CITY OF TACOMA

ADDENDUM NO. 2

DATE: November 12, 2019

**Request for Bids Specification No. PW19-0306F
TACOMA FIRE STATION #5**

MSK-01

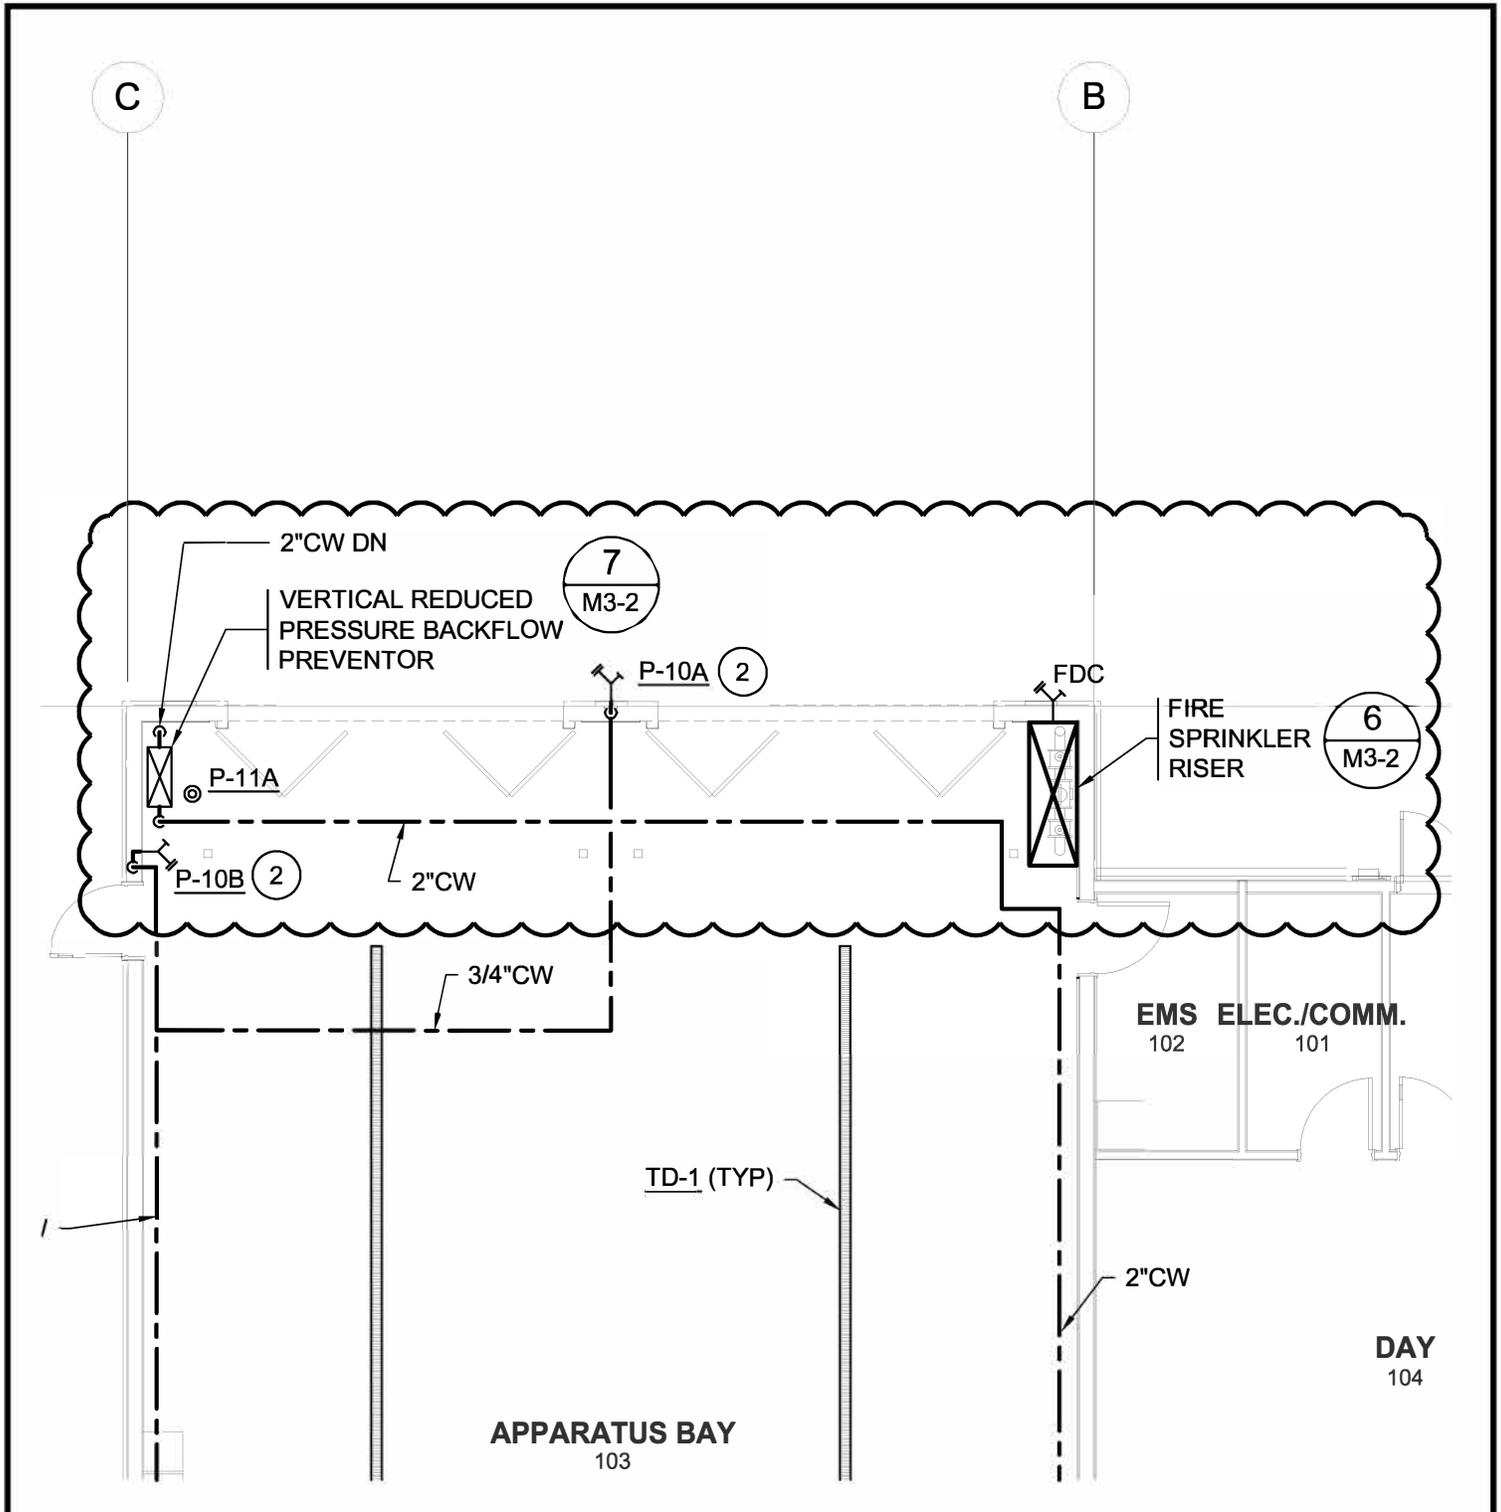
REVISE: Plumbing system to locate RPBA in the Apparatus Bay as shown on Addendum drawing MSK-01.

MSK-03

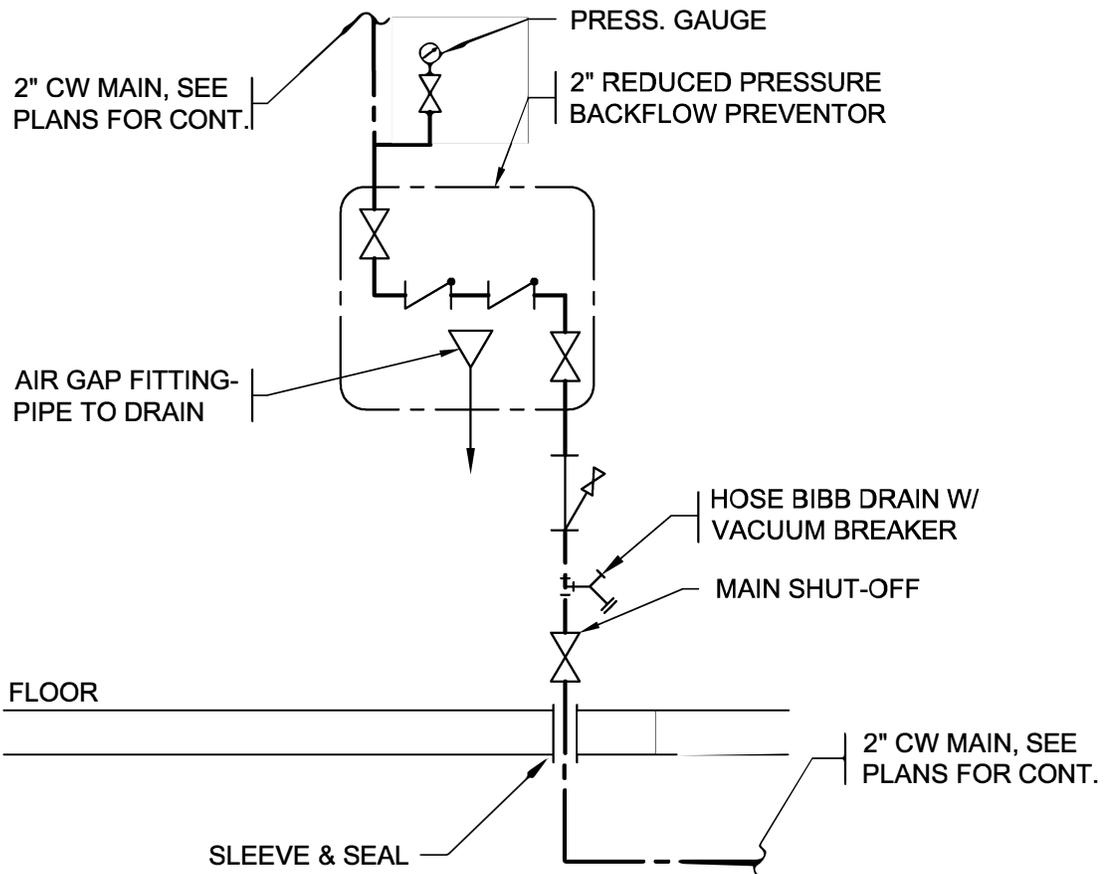
REVISE: Detail 2 to remove RPBA from the Water Header Detail as shown on Addendum drawing MSK-03.

MSK-04

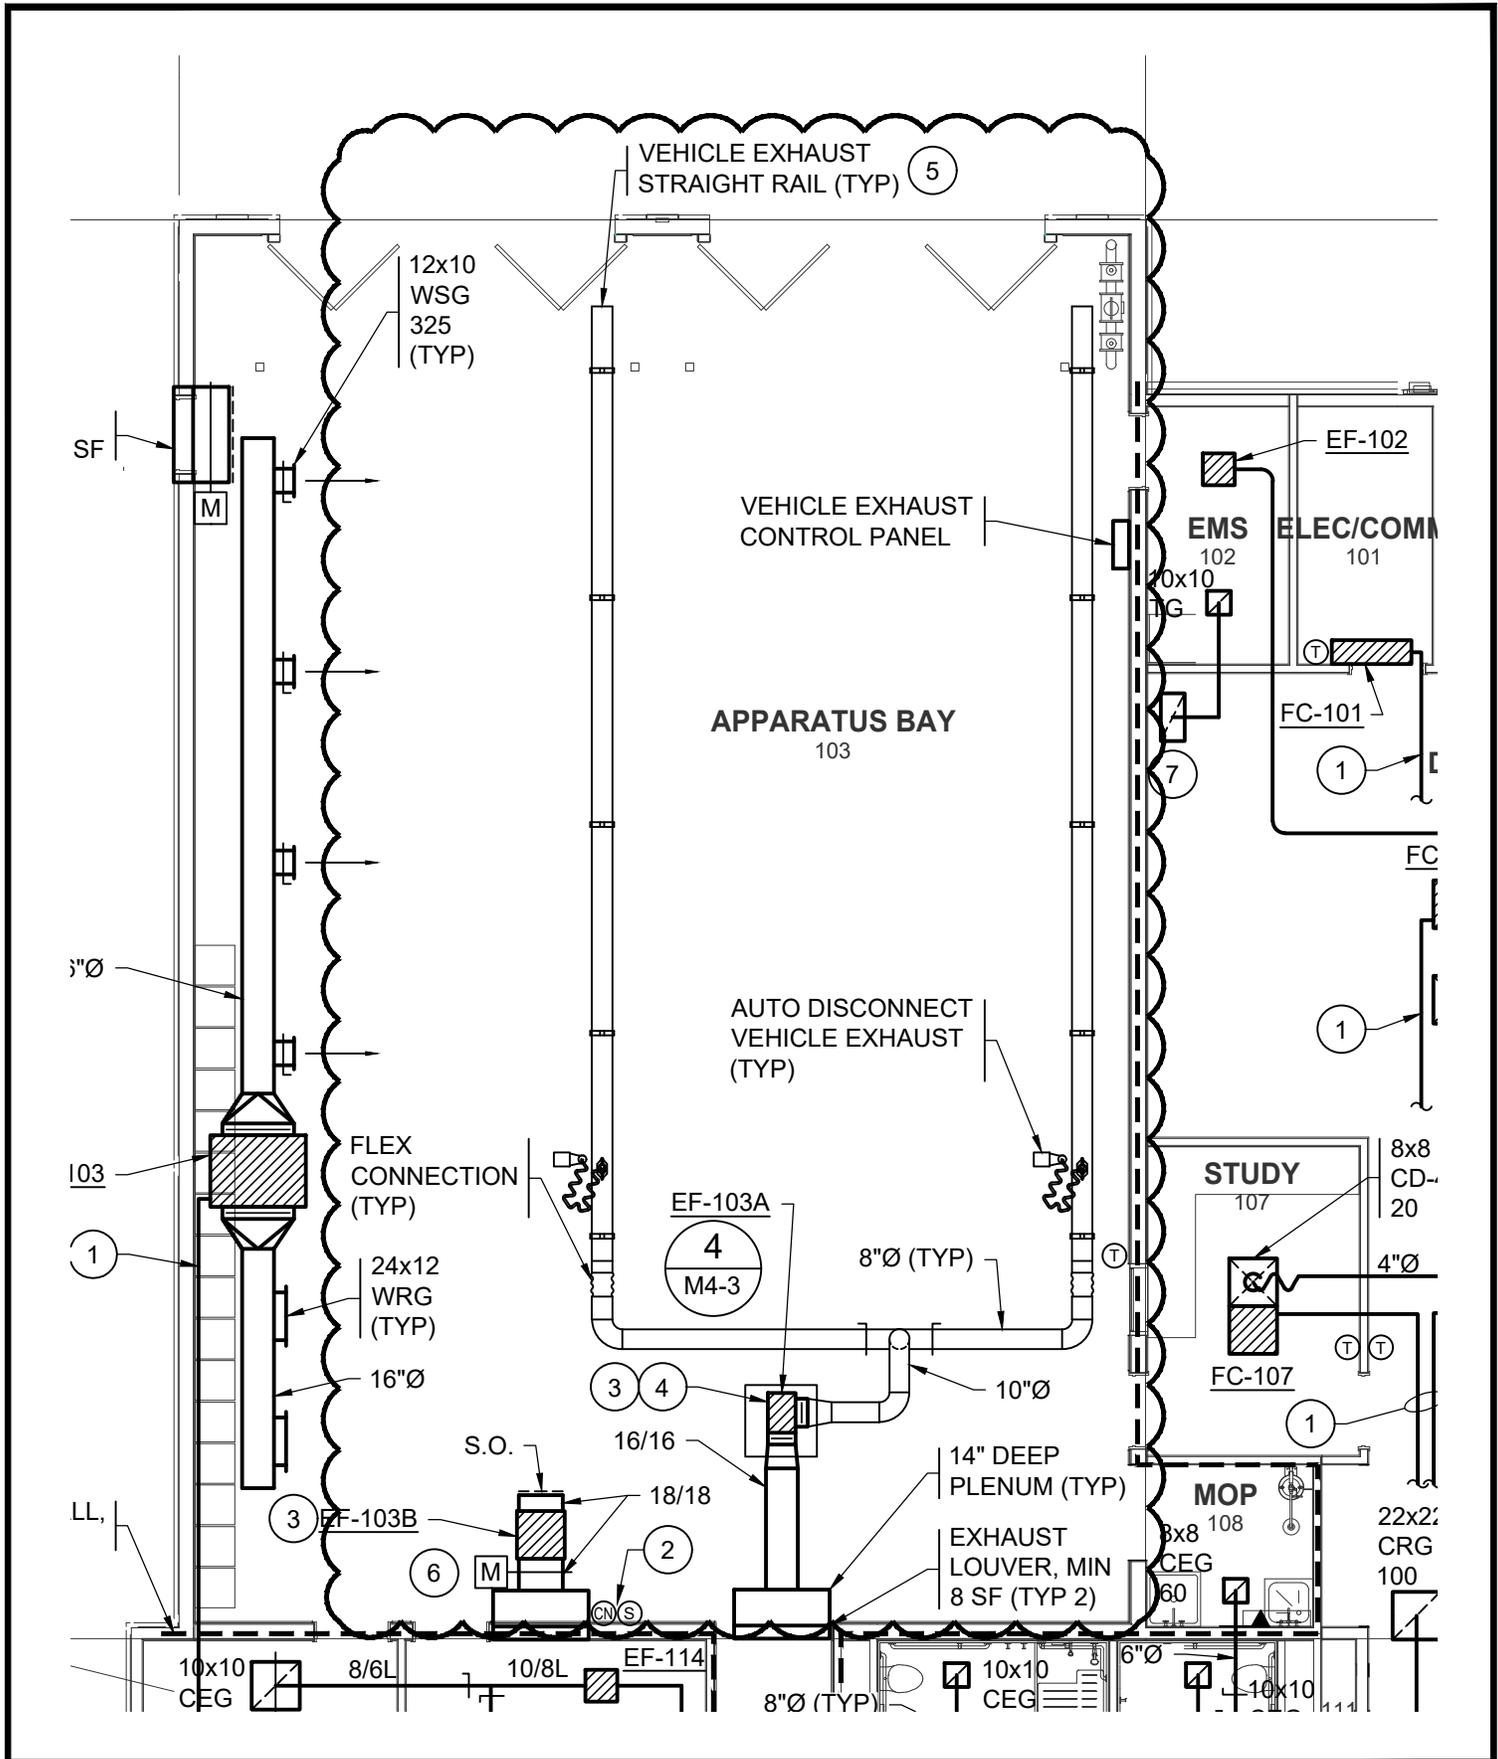
ADD: Detail 7 for Vertical RPBA revision as shown on Addendum drawing MSK-04.

Sheet Contents **ESK-03**
Project Title CITY OF TACOMA
FIRE STATION #5
ADDENDUM NO.2

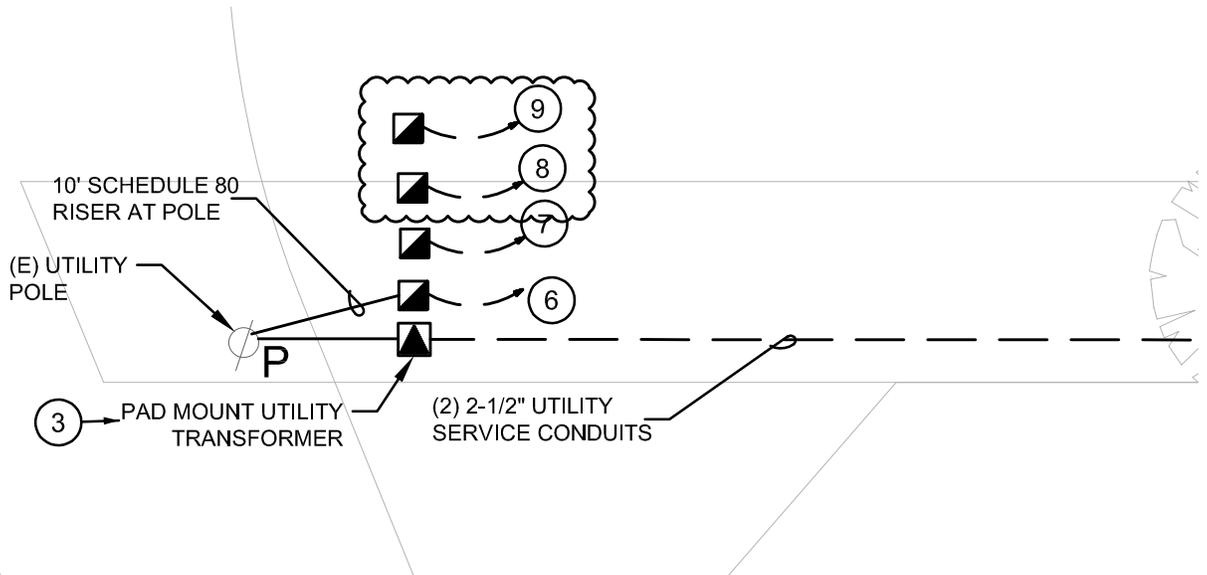
REVISE: Electrical Site Plan and Electrical Sheet Notes to add conduits for communications as shown on Addendum drawing ESK-03.

⑥ PROVIDE (1) 2" SCH 40 PVC CONDUIT WITH PULL STRING FROM CLICK VAULT TO TELEPHONE BACKBOARD IN COMM ROOM 101. COORDINATE VAULT LOCATION WITH PROVIDER.

⑦ PROVIDE (1) 4" SCH 40 PVC CONDUIT WITH PULL STRING FROM COMCAST VAULT TO TELEPHONE BACKBOARD IN COMM ROOM 101. COORDINATE VAULT LOCATION WITH PROVIDER.

⑧ PROVIDE (1) 2" SCH 40 PVC CONDUIT WITH PULL STRING FROM CENTURYLINK VAULT TO TELEPHONE BACKBOARD IN COMM ROOM 101. COORDINATE VAULT LOCATION WITH PROVIDER.

⑨ PROVIDE (1) 2-1/2" SCH 40 PVC CONDUIT WITH PULL STRING FROM HANDHOLE TO TELEPHONE BACKBOARD IN COMM ROOM 101 FOR FIRE DEPARTMENT FIBER. COORDINATE HANDHOLE LOCATION WITH CITY OF TACOMA.

PHASE: Bid Set
 JOB NO.: 17-04
 DATE: 9/24/19
 SHEET TITLE: Ground Improvement Plan
 SHEET NO.:

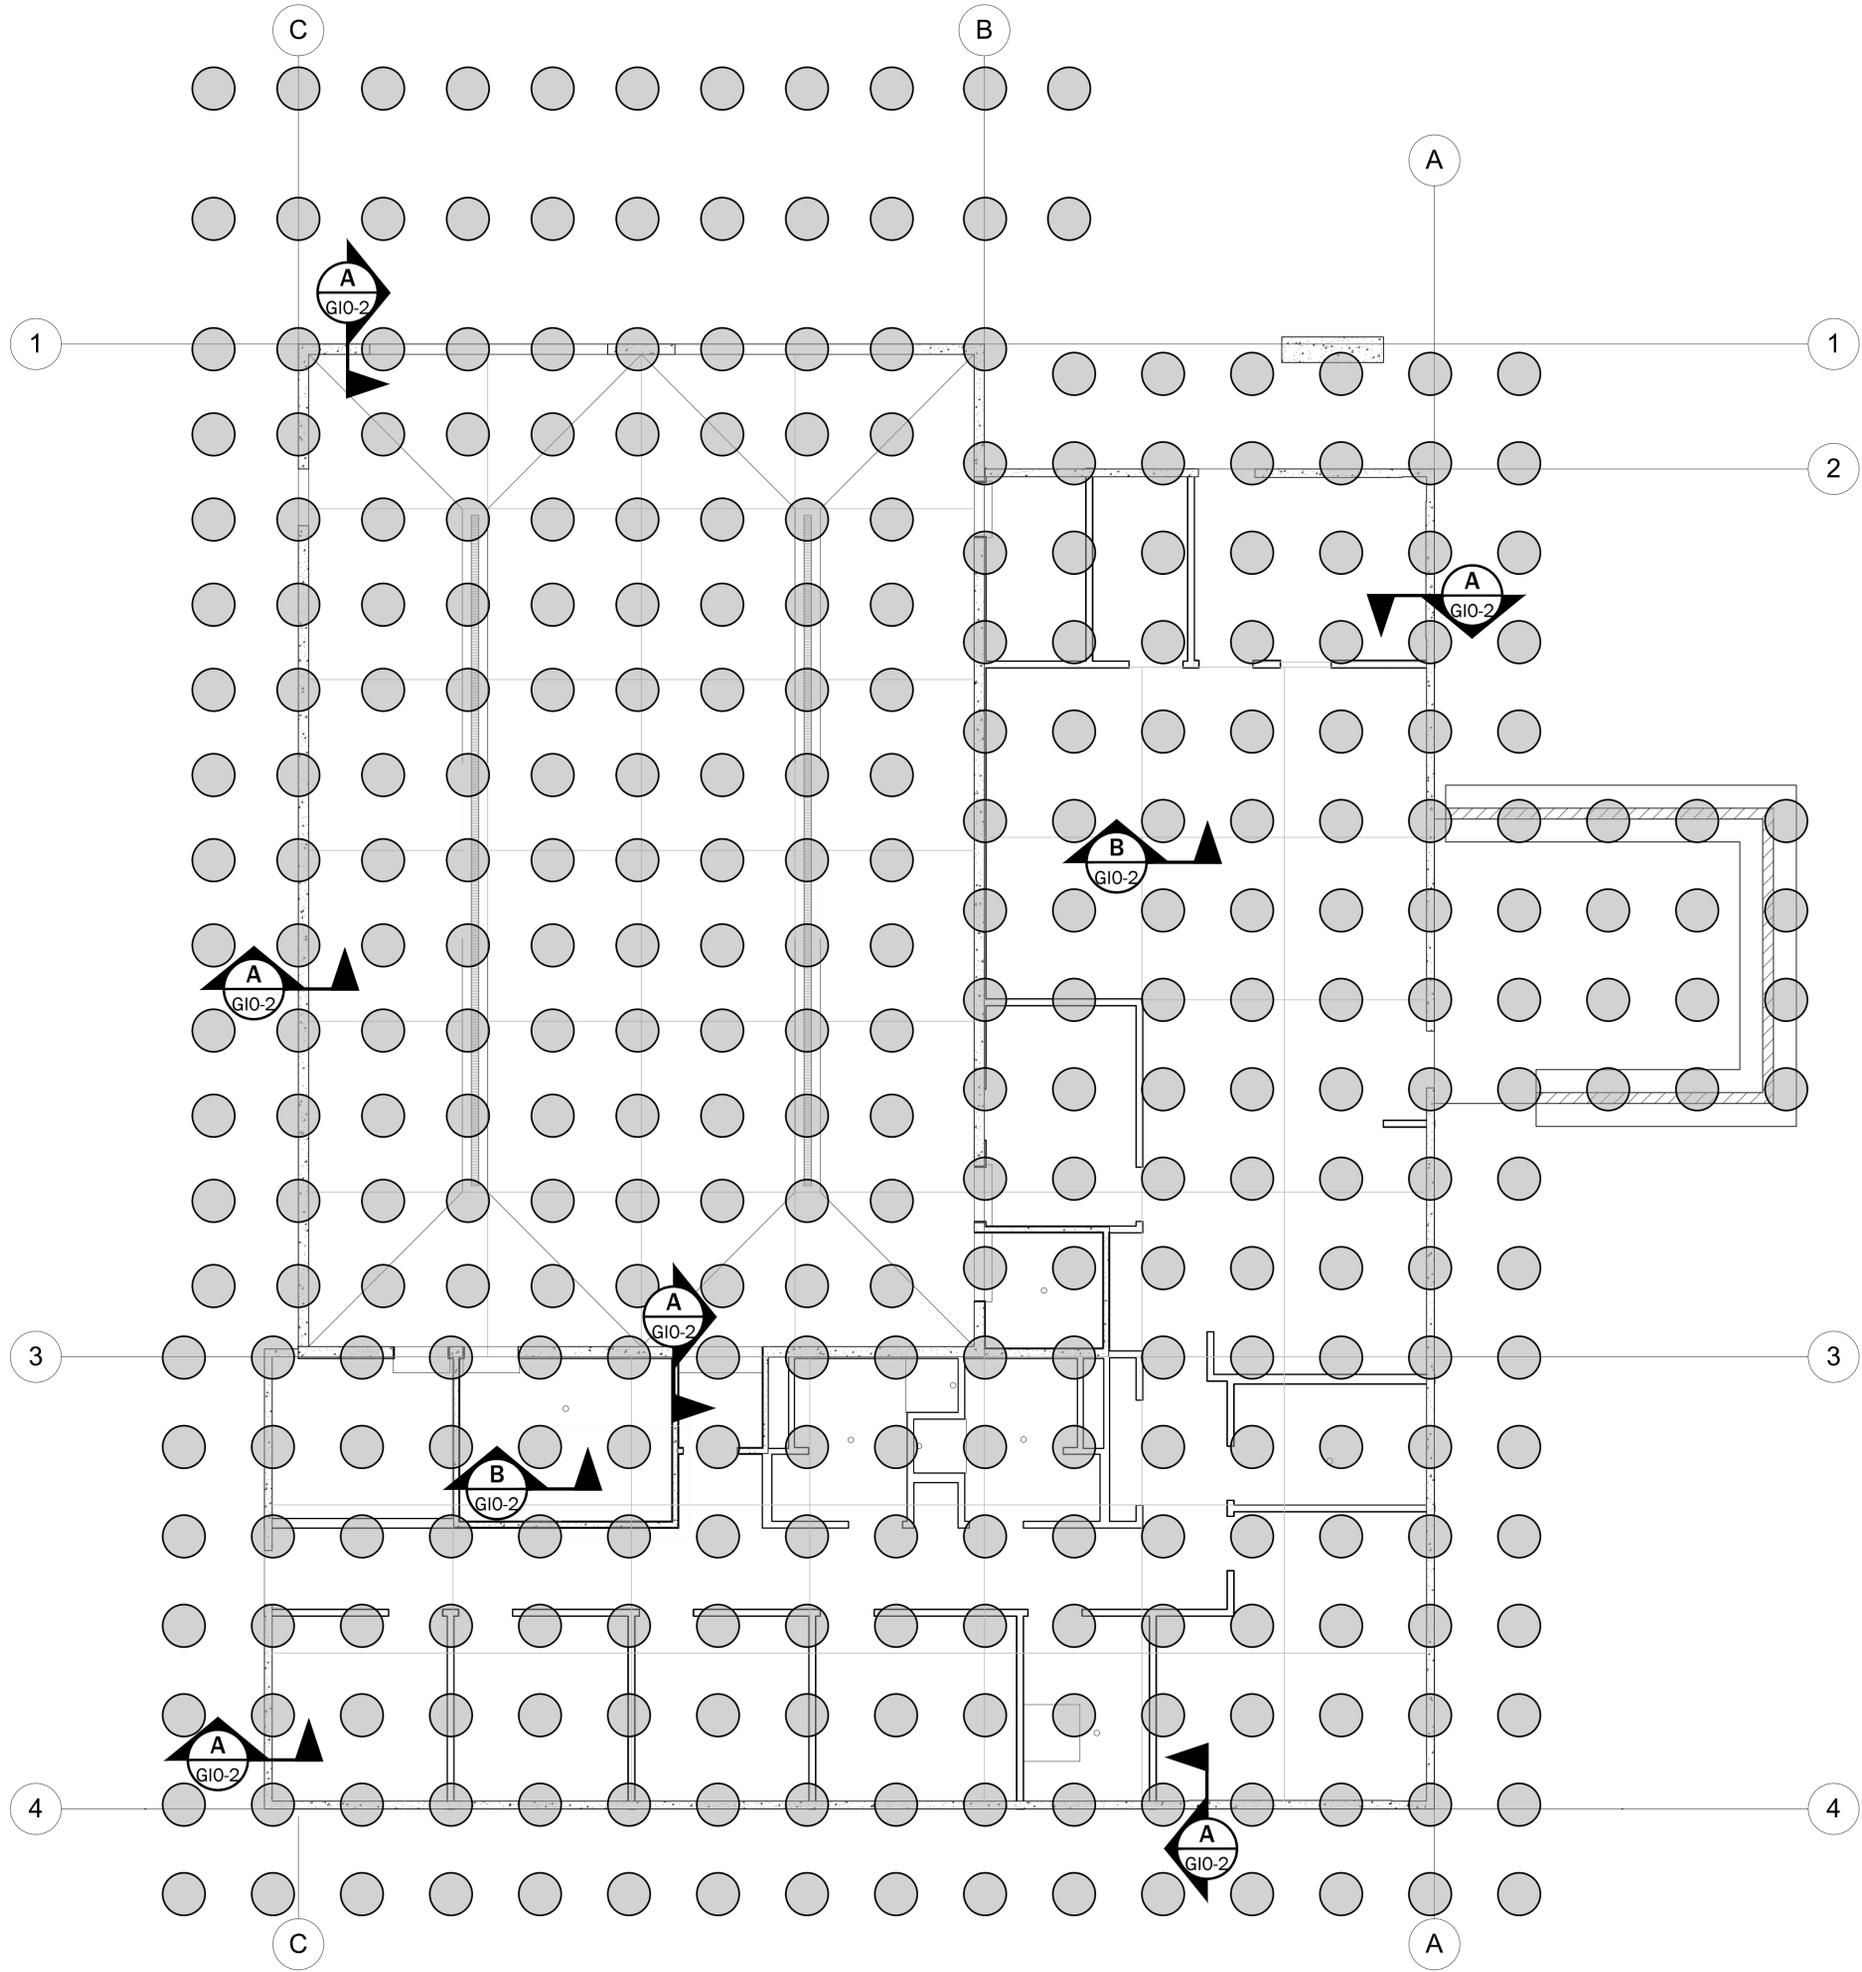
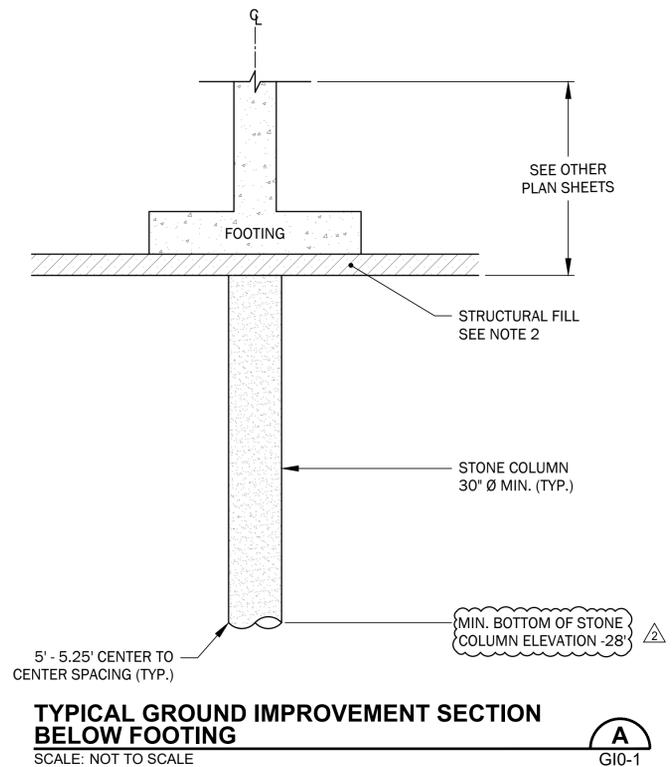
SHEET GI0-1 GROUND IMPROVEMENT PLAN

REVISE Note 4 to read:

“Stone Columns shall extend to elevation ~~-25~~ **-28** feet” as shown on the Addendum drawing.

This revision reflects the project vertical datum as shown on the Addendum drawing, and does not change the design length of the columns.
